**SUBJECT:** REVISION "A" TO ALERT SERVICE BULLETIN  
407-98-17: VERTICAL FIN ASSEMBLY P/N  
206-020-113-223A, 223B, OR -223S,  
INSPECTION AND REWORK OF.

Revision "A" to ASB 407-98-17 includes the changes that follow:

407

Figure 1. Inspection of the Vertical Fin (Sheet 1 of 3)

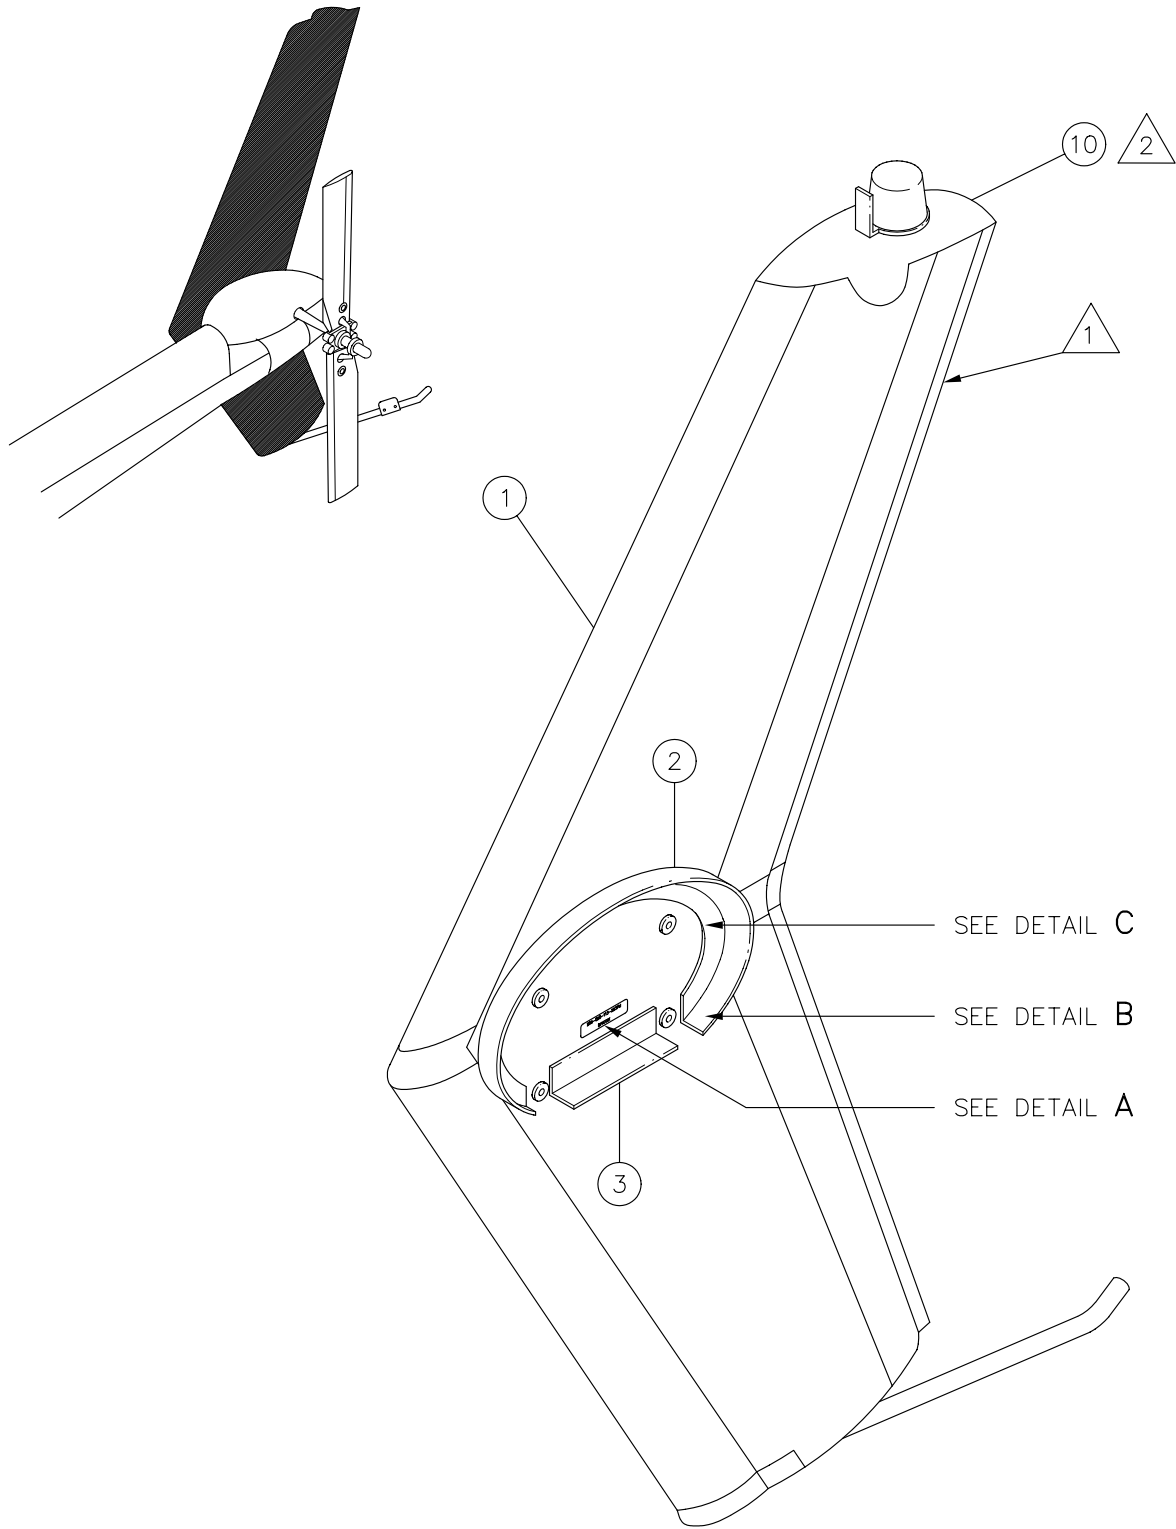
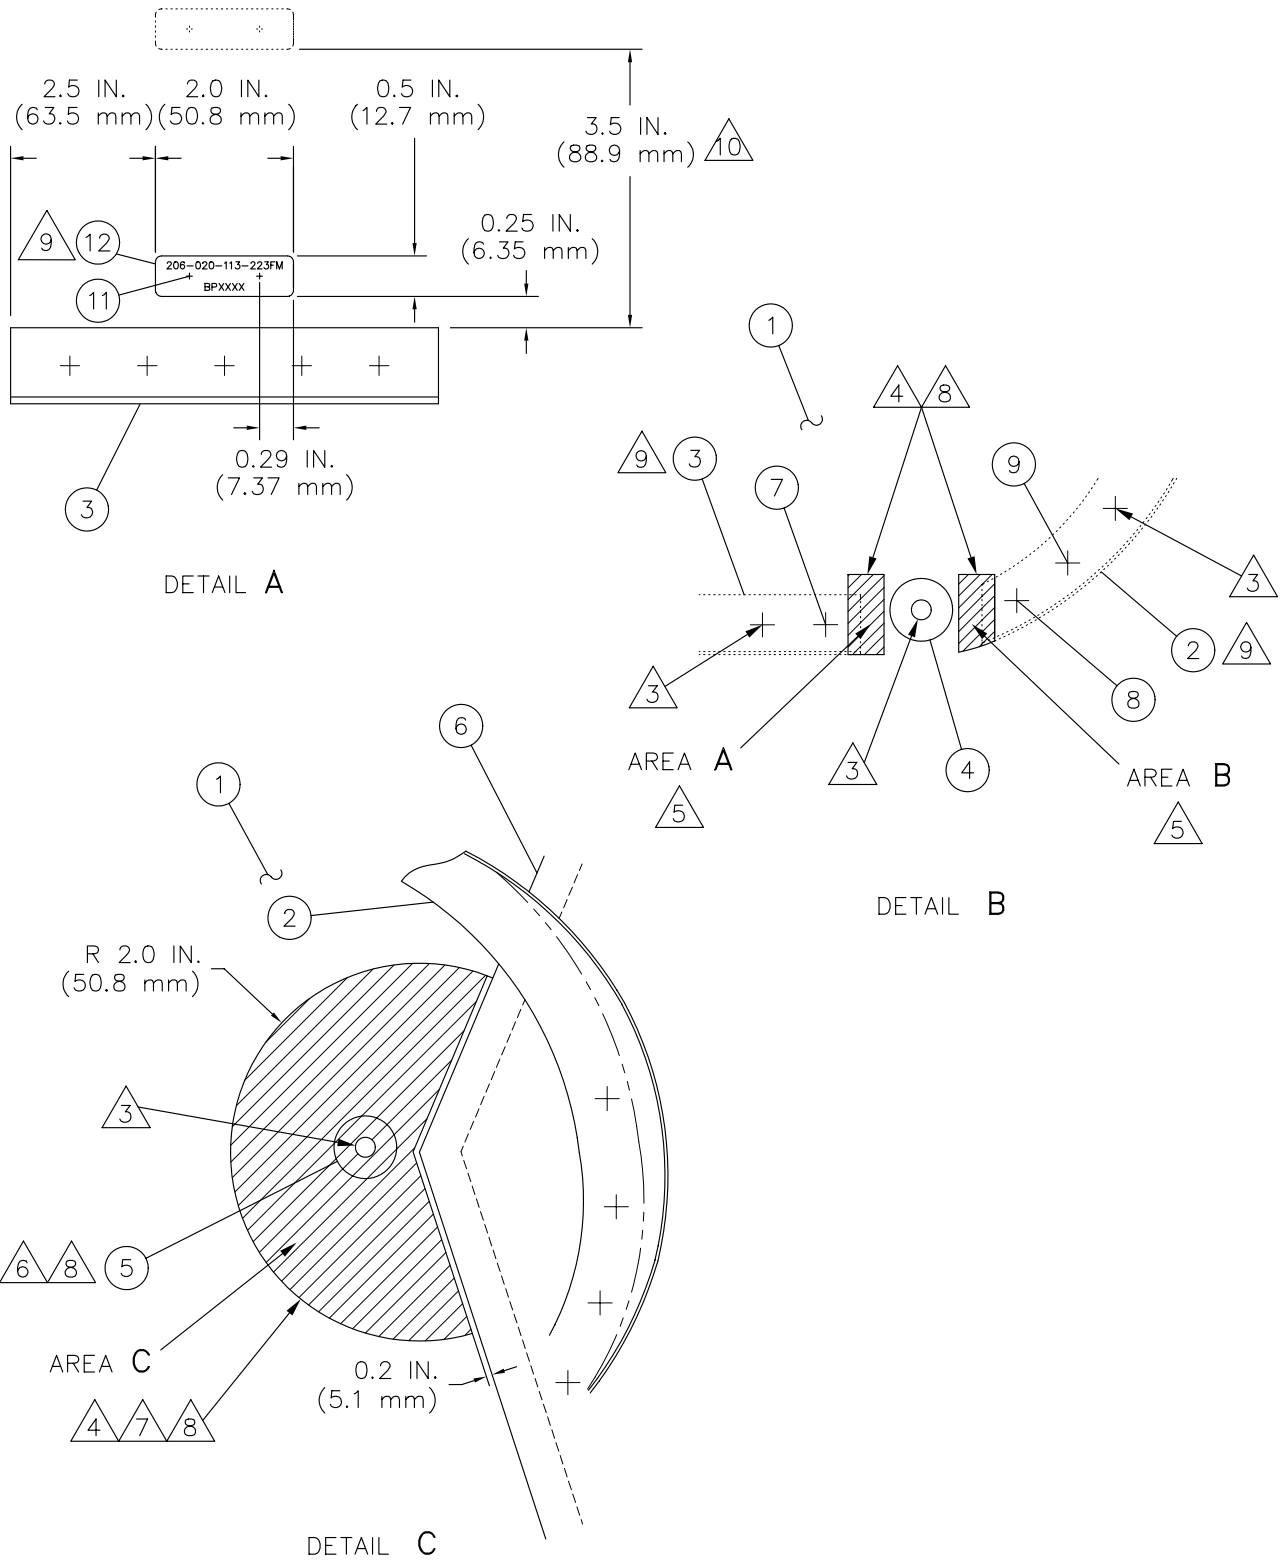
2. Examine the area around the aft lower insert (4, Figure 1, Detail B) as follows:
  - a. Remove the five rivets that hold former (3) in position. Remove former and keep for subsequent installation.
  - b. Remove six rivets from the aft end of former (2) and carefully lift the former to permit access for sanding and inspection.

- c. Use abrasive paper to remove paint and primer from areas A and B shown in Detail B. Do not remove metal. Do not remove primer from the surface of the insert head.

- d. Examine the area for damage. The possible damage is in the vertical direction and immediately adjacent to the ends of the formers (2) and (3). Look for notches, scratches or grooves on the skin.

- e. If you find damage, refer to Part II of this bulletin.
3. Examine the area around the aft upper insert (5, Figure 1, Detail C) as follows:
  - a. Use abrasive paper to remove paint and primer 2.0 inches (50.8 mm) around the area of the aft upper insert (5) as shown in Detail C. Do not remove metal.

- b. Examine the fin (1) around the aft upper insert (5). Look for notches, scratches or grooves on the skin.
  - c. If you find damage, refer to Part II of this bulletin.

- d. Examine the head of the plug insert for abrasion or grind marks.
  - e. If you find damage, replace the insert (refer to BHT-206-SRM-1, Chapter 3).

1. Use an aluminum alloy 2024T3 to make a nameplate with the dimensions that follow: 2.0 x 0.5 inch (50.8 x 12.7 mm), 0.032 inch (0.818 mm) thick. Drill two rivet holes (#27) in nameplate as shown in Figure 1, Detail A.
2. Vibro-etch the plate with the data that follow:  
P/N 206-020-113-223FM and applicable serial number  
BP()()()(), same as on bonded strip.
3. Clean the faying surface of the fin with solvent (C-309). Do not remove the paint or primer.

4. Locate nameplate on fin (Figure 1) and put rivet holes in fin.
5. Deburr holes in fin and nameplate. Prime plate and holes in fin. Allow to dry.
6. Apply sealant MIL-S-81733 to faying surfaces of nameplate and fin. While sealant is wet, use rivets M7885/6-4-02 made wet with sealant to install nameplate on fin.

2. Blend damage area(s) to a smooth finish (32 RMS or better). Abrasive cloth of grade 320 or finer will produce the required finish. Extend the blended area(s) 0.15 inch (3.81 mm) in all directions for each 0.010 inch (0.254 mm) of depth. Clean area fully with solvent (MEK or equivalent). Before the solvent dries, rub the area dry with a clean lint-free cloth.

7. If the depth of any of the damaged areas is more than 0.020 inch (0.508 mm), replace the vertical fin with a serviceable unit as follows:

8. If the depth of each blended area around the inserts (4) and (5) is 0.020 inch (0.508 mm) or less, do as follows:

- b. Apply primer (C-204) to all bare metal surfaces.
  - c. Apply sealant (C-392) to the faying surfaces of the formers and fin (1).
  - d. While the sealant is still wet, use the holes made by the rivets that you removed to attach the former (3) to the fin (1) with rivets (M7885/6-4-02), and former (2) to the fin (1) with one rivet (M7885/6-4-02) and five rivets (M7885/6-4-01). Install the rivets made wet with sealant. Make a fillet of sealant around the edges of the formers.
